Base Load Power Hub (BLPH)

90% 3D Model Review Report

Document Number: 123A90-DDL-PP-RE-70010

BLPH - 90% 3D MODEL REVIEW
ACTION ITEM REGISTER

MR90-TAG16

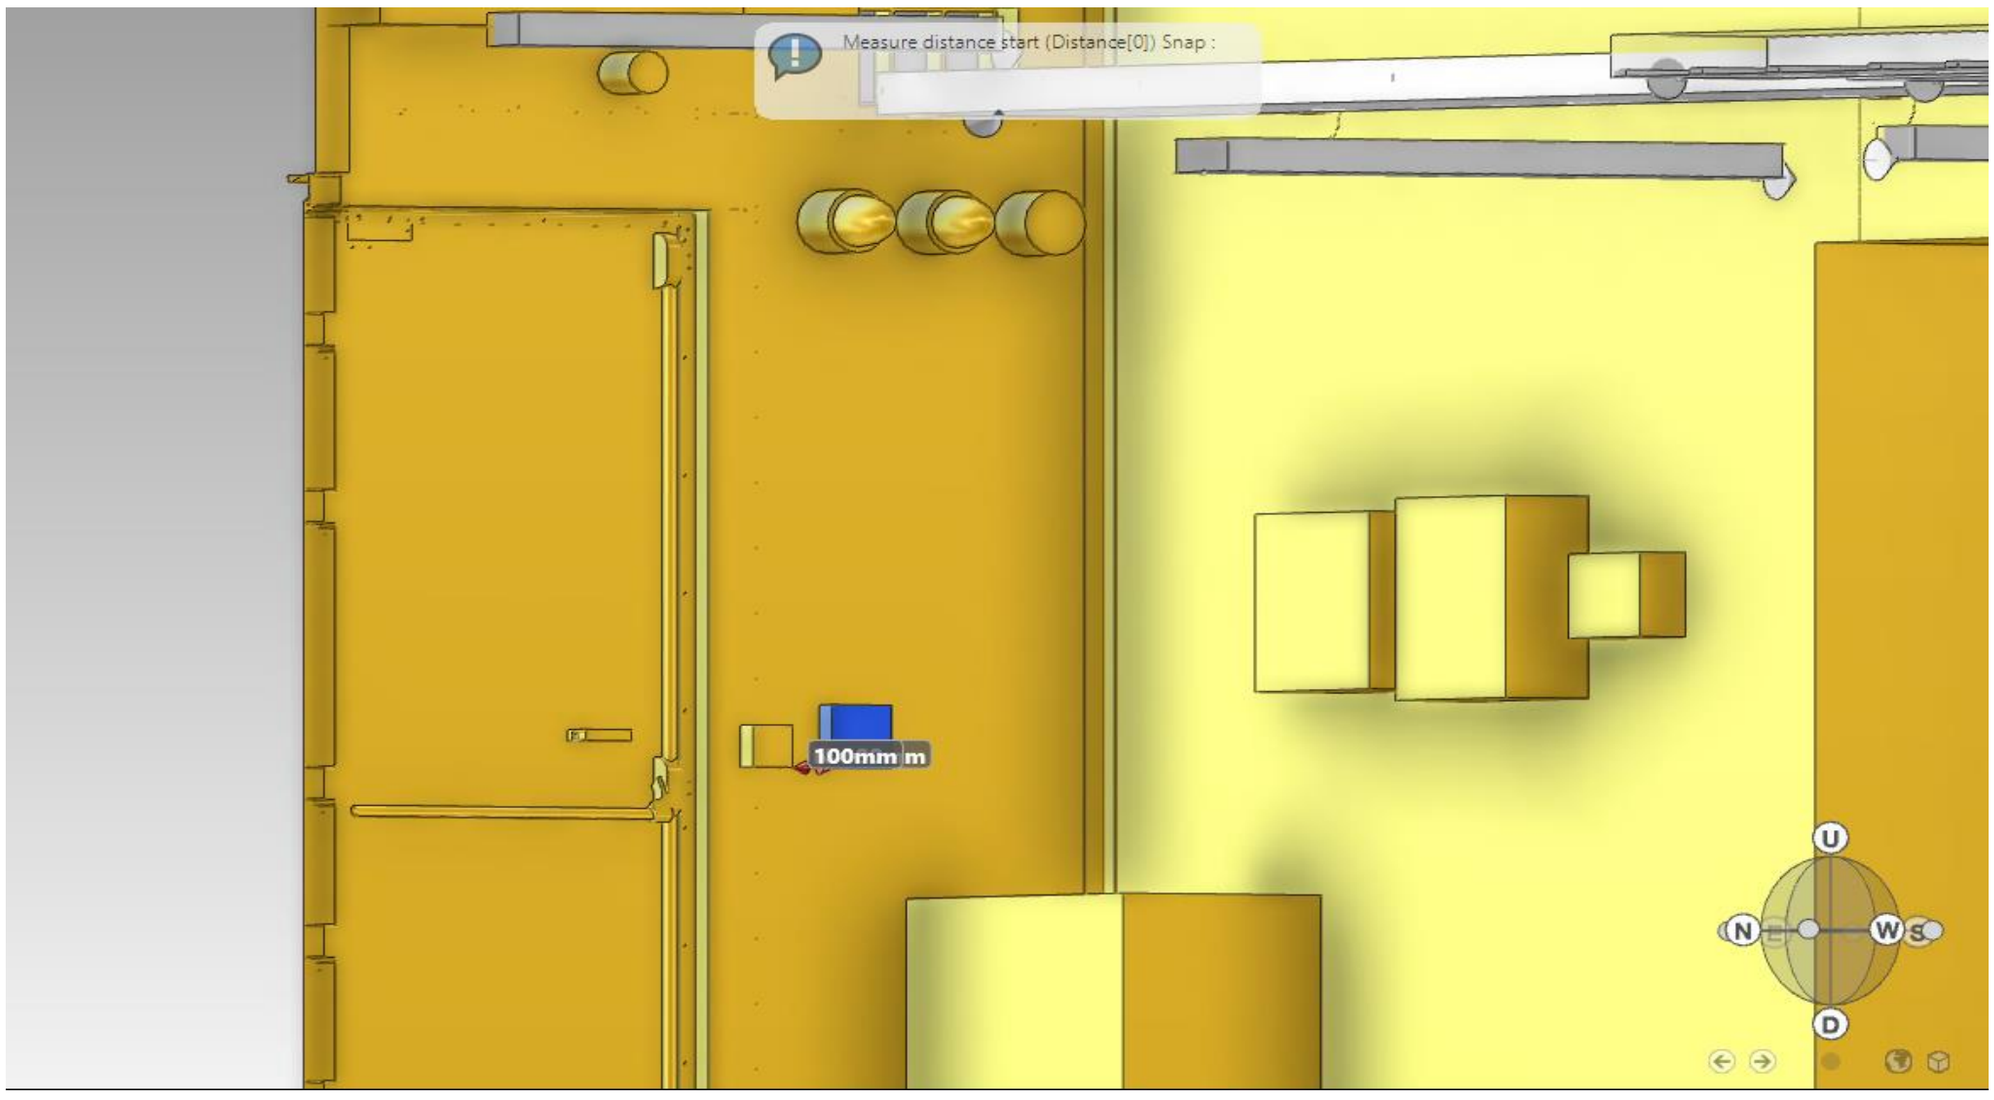
Manual call point 04201 shall be moved close the door

Manual Call Point has been moved close to opposite door together to beacons and sounder for space missing.

MR90-TAG17

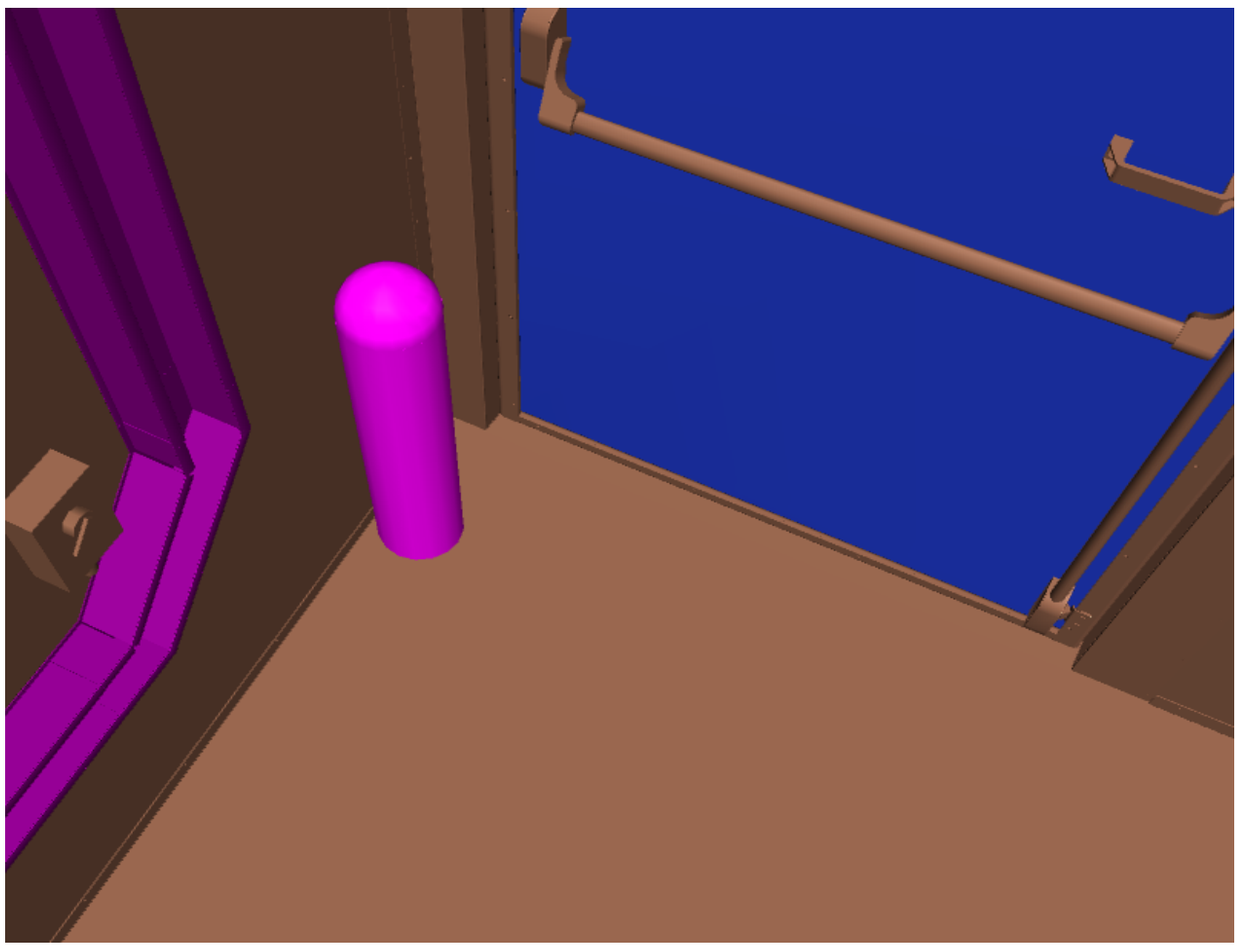
Extinguisher shall be moved

The fire extinguisher has been moved

MR30-TAG07

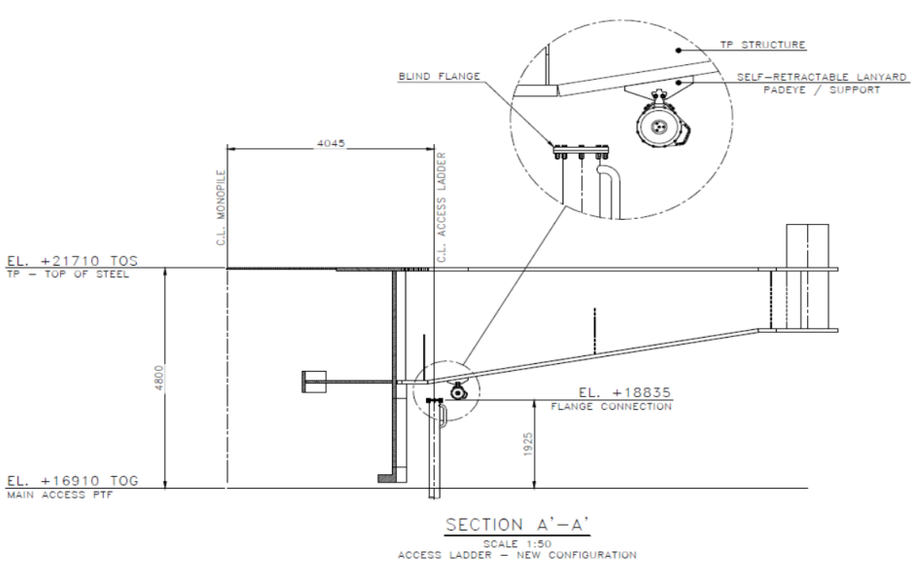
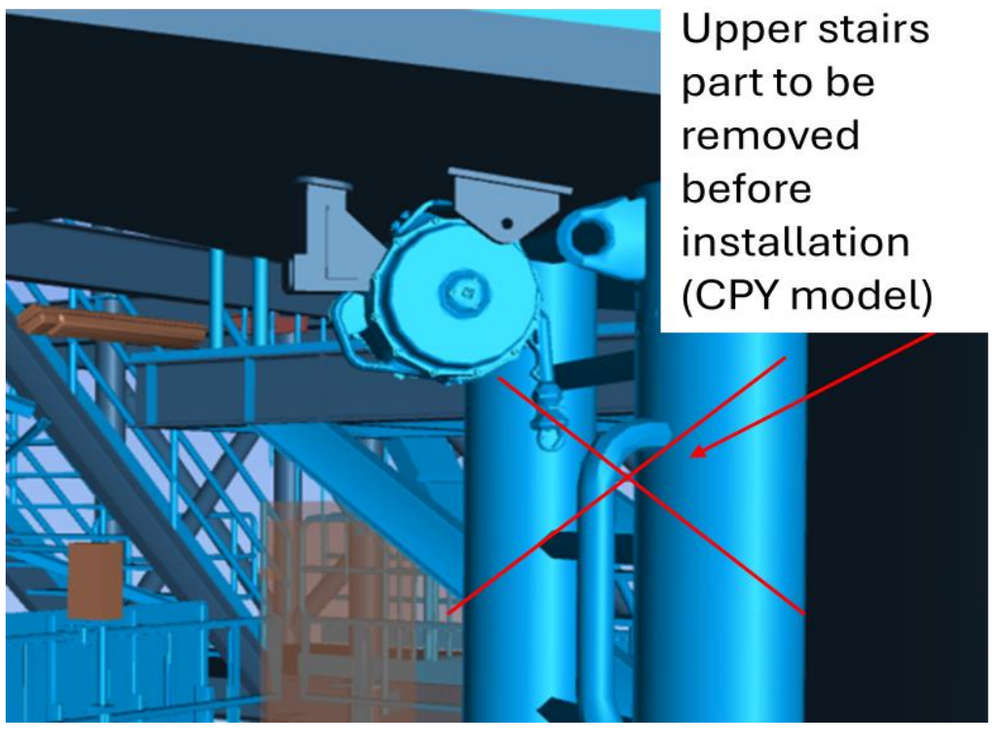
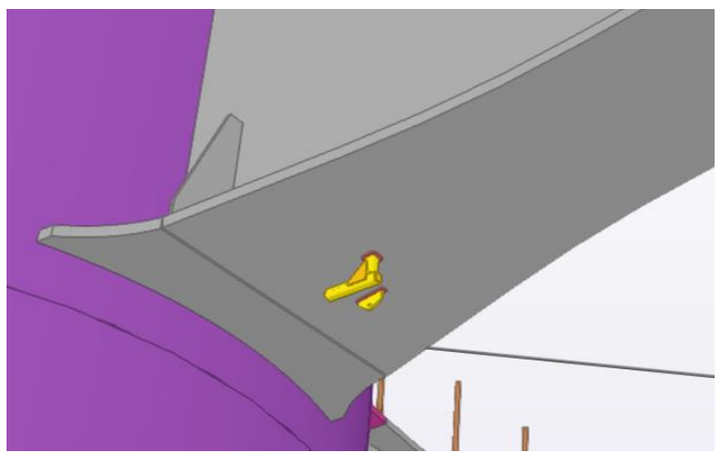
Anchor point for existing winch to be shown.

Anchor point for new winch will be installed on TP. Temporarily the exisiting SRL system will be fixed with a soft sling to the access ladder (solution already used in the past)

MR60-TAG03

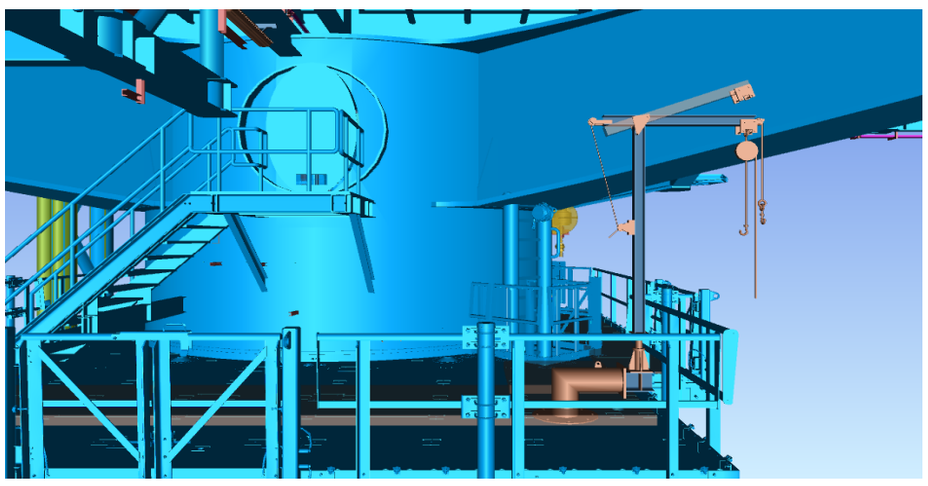
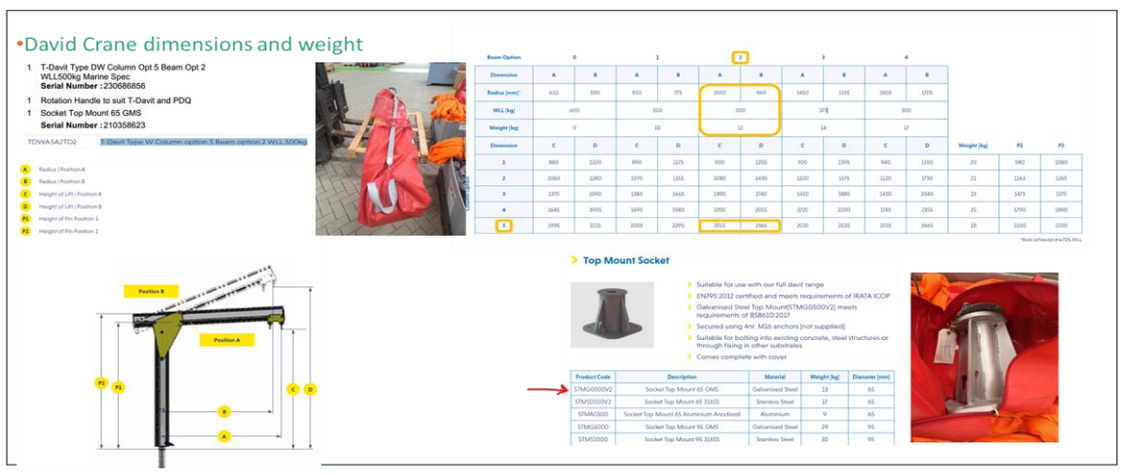
To provide portable CPY Crane

The portable CPY Crane has been added

MR60-TAG08

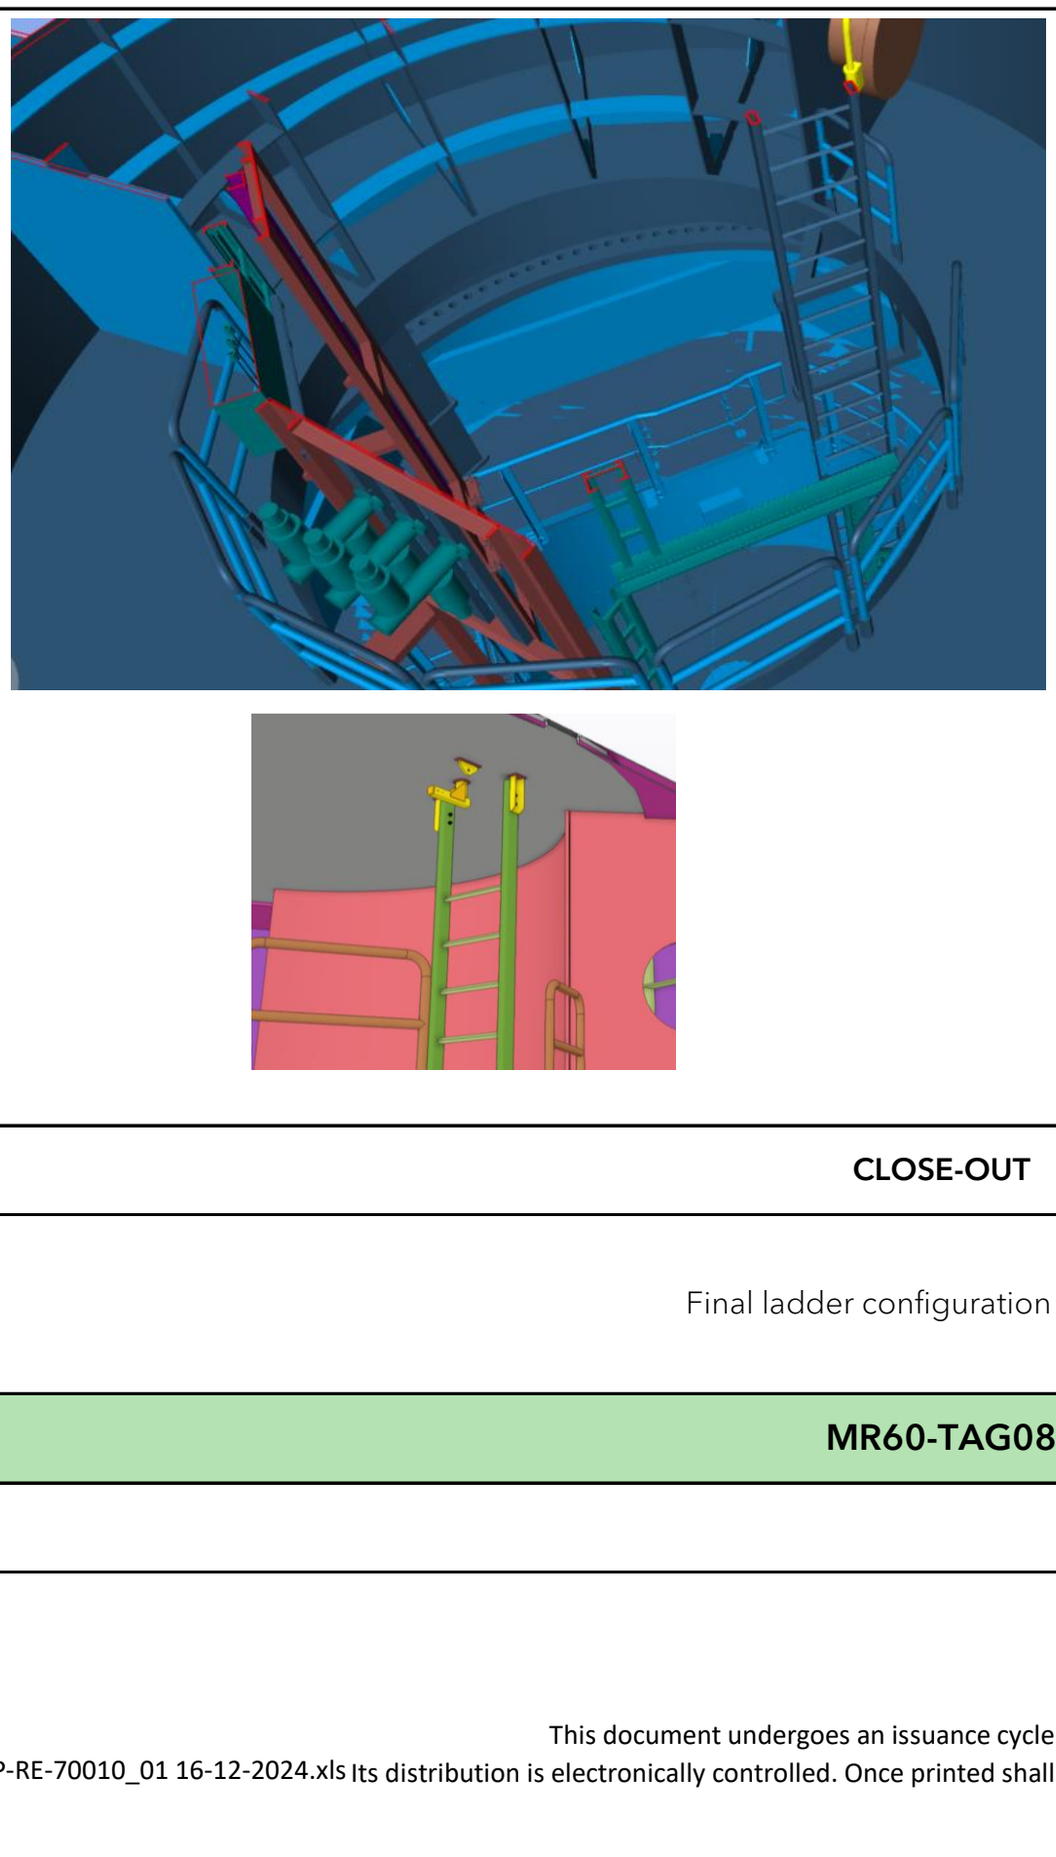
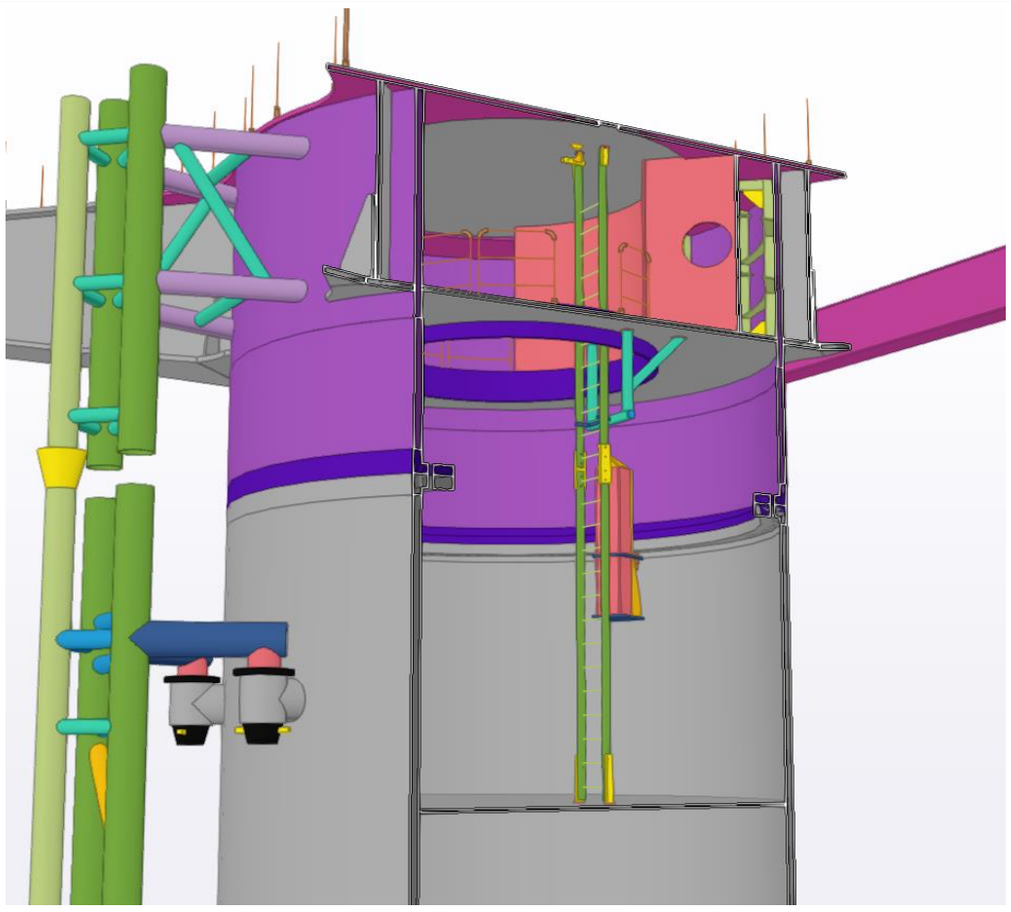
Update the ladder with final configuration agreed with CPY

Final ladder configuration modelled
